Falcon Falls 2nd Addition
LINE 2
SANITARY SEWER IMPROVEMENTS

PROJECT NUMBER
468-84065

SHEET
8R OF 32

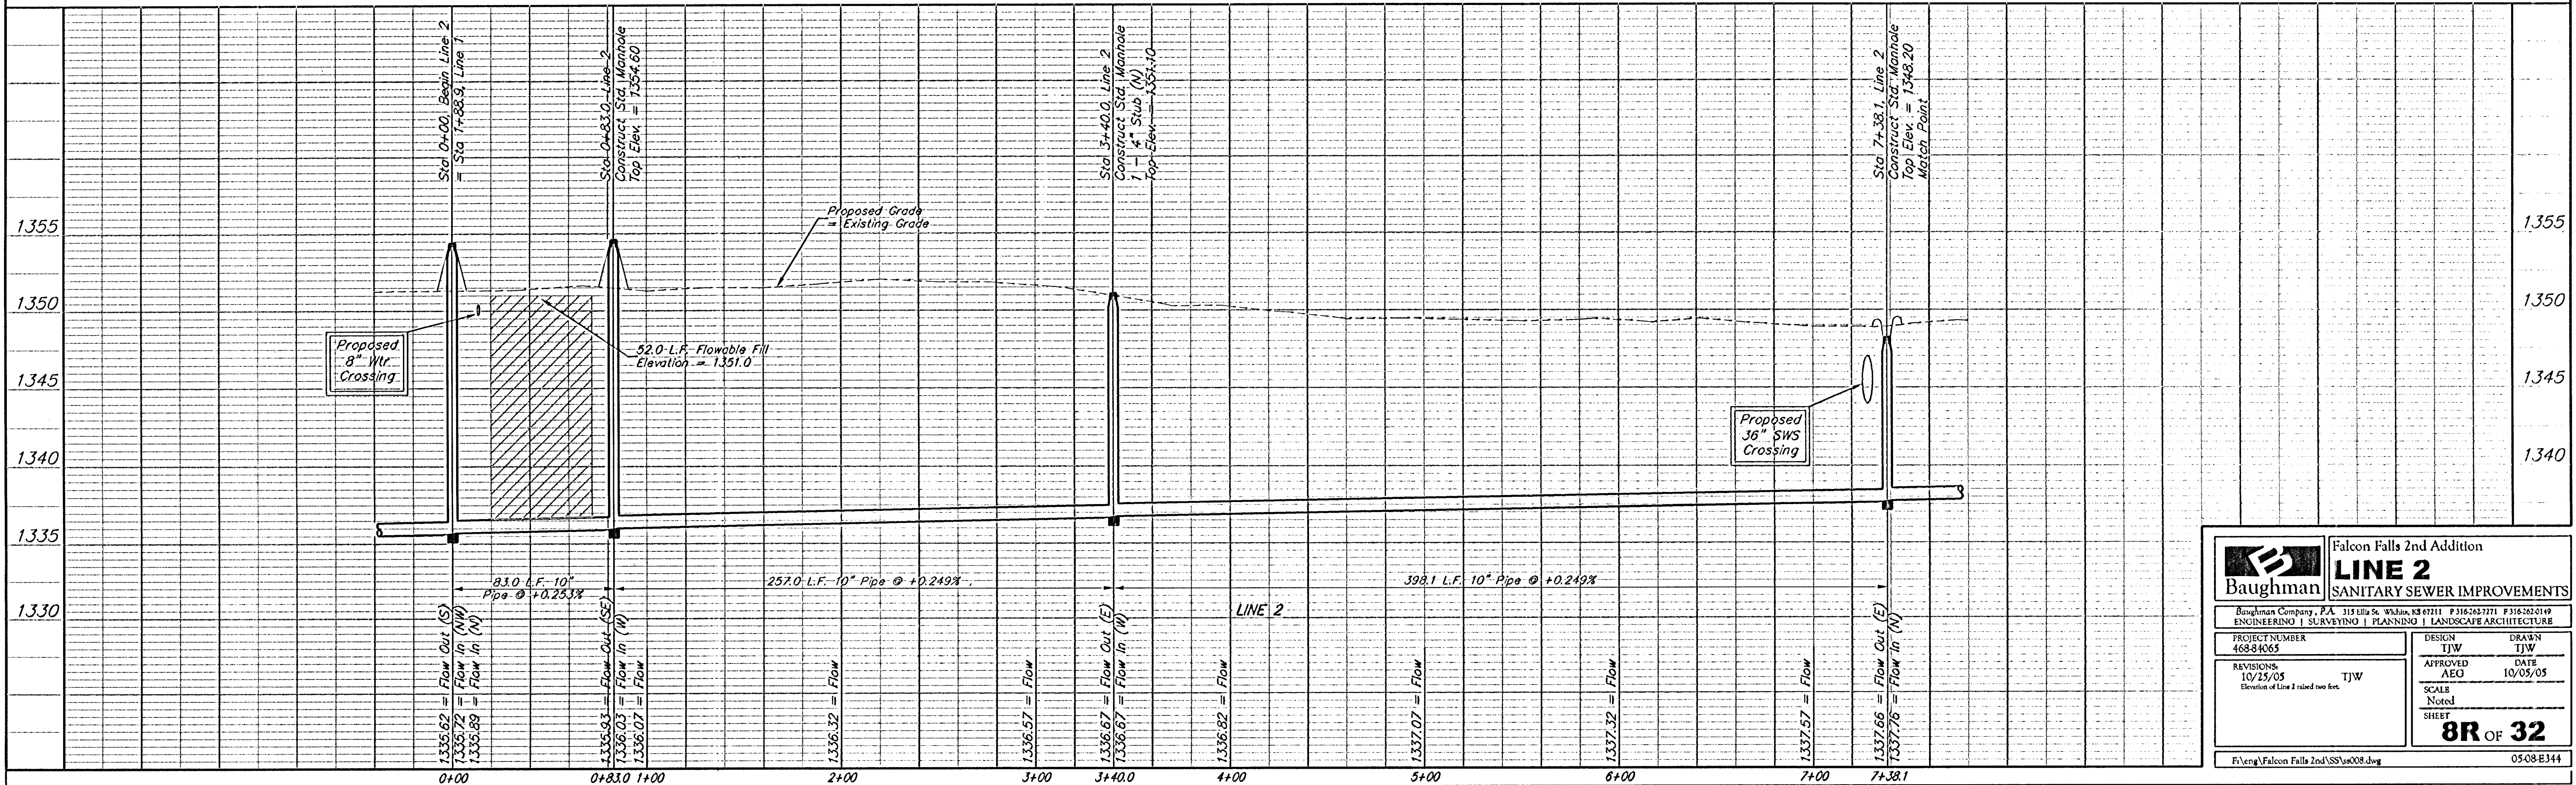
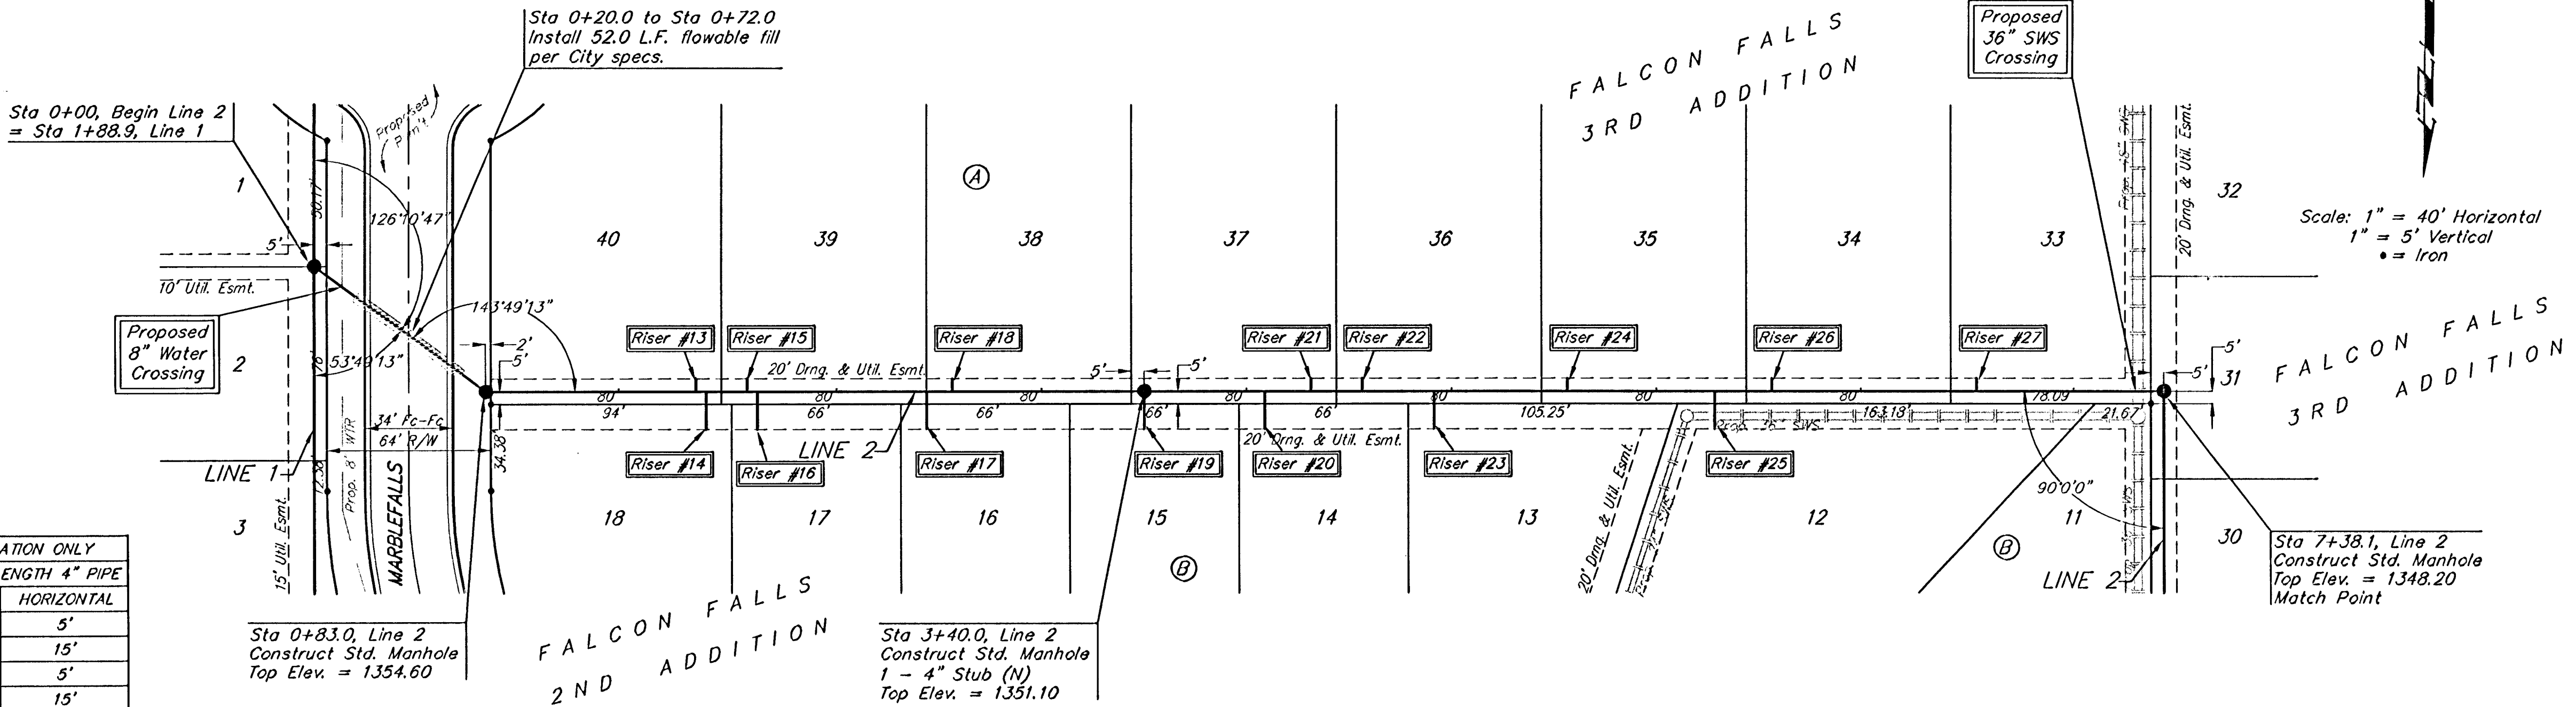
REVISIONS:
10/25/05
Elevation of Line 2 raised two feet.
